February 11, 2020 Planning Board Meeting

OFF HIGHLAND AVE/ABBY ROAD SUBDIVISION

TO: Winchester Planning Board
FROM: Beth Rudolph, PE, Town Engineer *BER*
DATE: February 6, 2020
RE: Abby Road Subdivision – Request for Release of Lots

B CATCH BASIN
 NOT TO SCALE

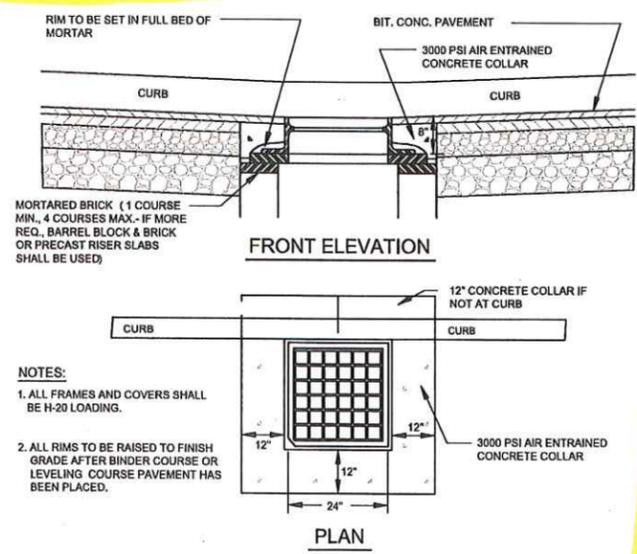
- (7) Catchbasins – The approved subdivision plans called for the installation of four double-grate catchbasins in the right-of-way. The catchbasin details were shown on Sheet D-1 of the approved subdivision plans (see Attachment 3). These details show that the catchbasin grate was to have square openings and be installed directly against the curbing to prevent runoff from flowing around the basin. The detail also notes that the catchbasins grates shall be three-flanged. There are several issues with the catchbasins, as installed:

- b. At least two of the catchbasins are four-flanged, not three-flanged as called out in the approved subdivision plans. These basins shall be replaced in accordance with the approved plans.

- c. Two of the catchbasin grates are a non-standard grate opening. The applicant shall provide calculations to show that they have the same inlet capacity as the standard, square grate, and if they do not, they should be replaced.

Attachment 3 – Catchbasin Photos from February 4 & 5, 2020

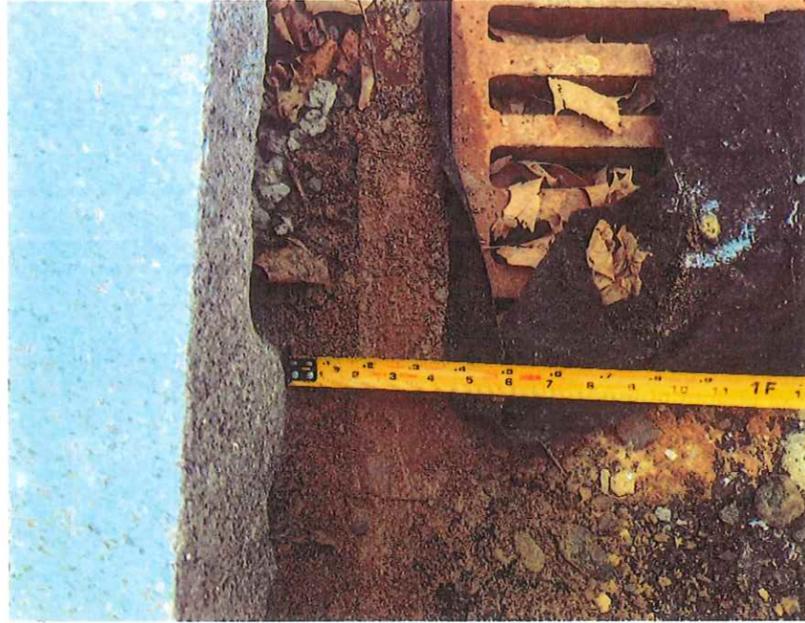
- a. Three of the catchbasins have been installed 3 to 7-inches from the curb line (see photos in Attachment 3). The fourth is in a driveway opening, so there is no curbing here. As a result, stormwater runoff can flow behind the basins and down the curblines, completely circumventing the drainage system. The catchbasins need to be reset to the curblines in accordance with the details in the approved subdivision plans. Additionally, instead of using straight curbing behind the basins, the applicant installed curb-inlet type, even though the basins are not designed to act as curb inlets. Leaves and other debris will collect in the indent in the curbing.

Attachment 4 – Sewer Manhole Photos from February 4, 2020

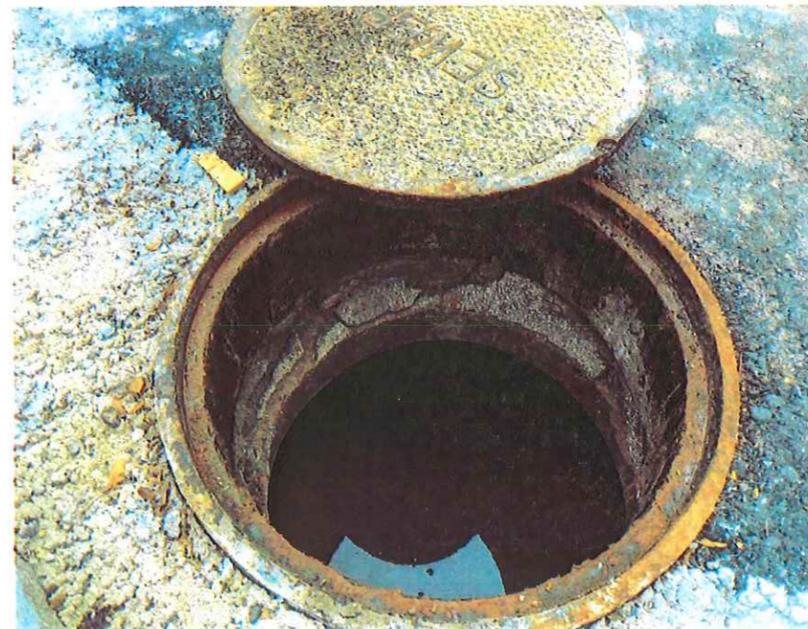
- (8) Sewer Manholes – There were six sewer manholes installed as part of the Abby Road construction, including one where the sewer line from Abby Road ties into the sewer line in Highland Avenue. The Engineering Department identified several deficiencies in these manholes during our site inspection, as noted below:

- a. Overall, the workmanship of the brick in the bottom of all the sewer manholes is poor quality, and very rough. The Engineering Department is concerned that solids and paper will get caught as sewerage flows through the manholes, causing clogging and back-ups. The inverts need to be repaired to address this concern.

- b. All of the sewer manholes currently have water pooling in them, even though there is no flow connected to the system. The Engineering Department and DPW are concerned that the bottom of the sewer manholes are not positively draining. Prior to the release of lots, the applicant should be required to survey the inlet and outlet inverts elevations at each sewer manhole to confirm that the inlet is higher than the outlet and provide a plan showing that information to the Engineering Department, and to confirm that the brick at the bottom of the manholes is positively draining towards the outlet.

- c. All of the sewer manholes have dirt and debris at the bottom of the manhole (see photos in Attachment 3), with SMH-3 being the worst. The applicant should be required to clean each sewer manhole prior to the release of any lots.

- d. SMH-4 is completely filled with water. The applicant needs to investigate what the issue is here and remedy the situation. Additionally, the rim and cover on this SMH has been knocked off and needs to be adjusted (see Attachment 4).

- e. The drop inlet connection in SMH-5 connecting the Abby Road sewer line to the pipe in Highland Avenue is not connected. Prior to the release of any lots, the applicant needs to reinstall this connection and secure it with stainless hardware to the satisfaction of the DPW.
